## DEVELOPMENT APPLICATION ASSESSMENT REPORT

<b>Application Number:</b>	DA2022/2256
<b>Responsible Officer:</b>	Maxwell Duncan
<b>Land to be developed (Address):</b>	Lot 100 DP 1009880, 22 Raglan Street MANLY NSW 2095
<b>Proposed Development:</b>	Demolition works and construction of a mixed use development with basement car parking.
<b>Zoning:</b>	Manly LEP2013 - Land zoned R3 Medium Density Residential
<b>Development Permissible:</b>	Yes
<b>Existing Use Rights:</b>	No
<b>Consent Authority:</b>	Northern Beaches Council
<b>Delegation Level:</b>	NBLPP
<b>Land and Environment Court Action:</b>	Yes
<b>Owner:</b>	Para-Ere Holdings Pty Ltd
<b>Applicant:</b>	The Trustee For The Para Erep Trust
<b>Application Lodged:</b>	25/01/2023
<b>Integrated Development:</b>	No
<b>Designated Development:</b>	No
<b>State Reporting Category:</b>	Mixed
<b>Notified:</b>	03/02/2023 to 03/03/2023
<b>Advertised:</b>	03/02/2023
<b>Submissions Received:</b>	8
<b>Clause 4.6 Variation:</b>	4.3 Height of buildings: 31.8% 4.4 Floor space ratio: 135.6%

This development application seeks consent for demolition works and construction of a four (4) storey mixed use development, comprising 10 apartments, 1 ground floo

**Figure 1 - Building height non-compliance**

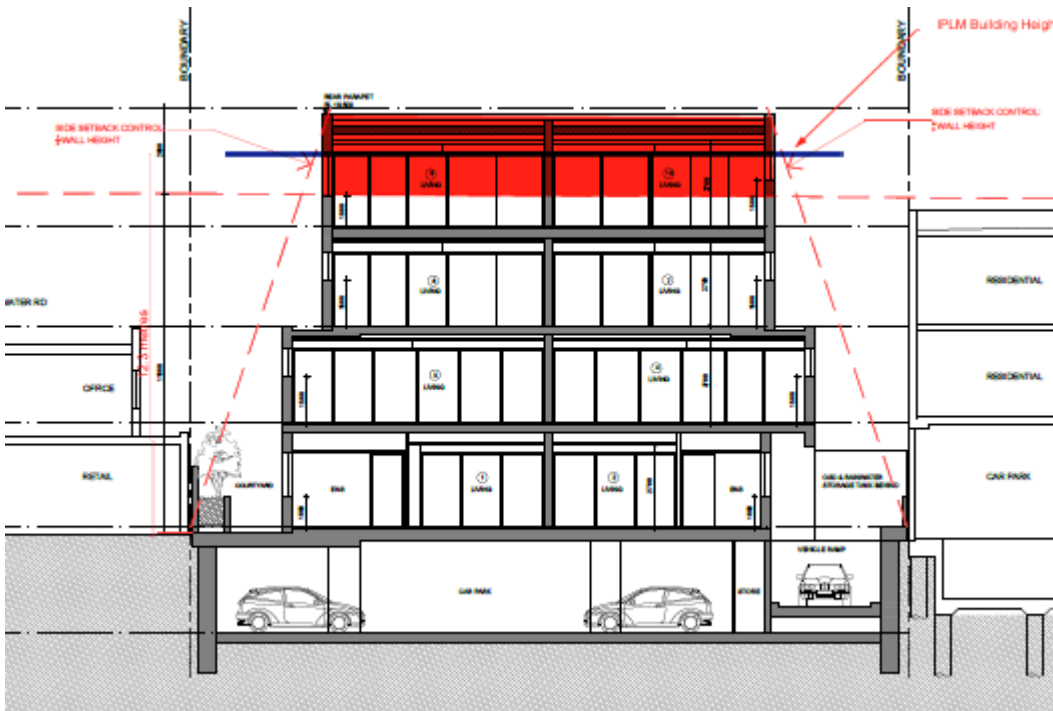
Development standard:	Height of buildings
Requirement:	11m
Proposed:	13.2m - 14.5m
Percentage variation to requirement:	31.8%

The applicant's request argues that the proposed breach to the height control is compatible with nearby development. The proposed development is not considered to be compatible with regard to the bulk and scale with neighbouring development, neighbouring development which is subject to the 11m height and control and within R3 Medium Density zone are all limited to three storeys, allowing for an additional storey above the height plane would start a precedent for new development to breach the control. The planning ground are not considered sufficient planning grounds to vary the development standard.

Therefore, the applicant's written request has not adequately demonstrated that there are sufficient environmental planning grounds to justify contravening the development standard as required by cl 4.6 (3)(b).
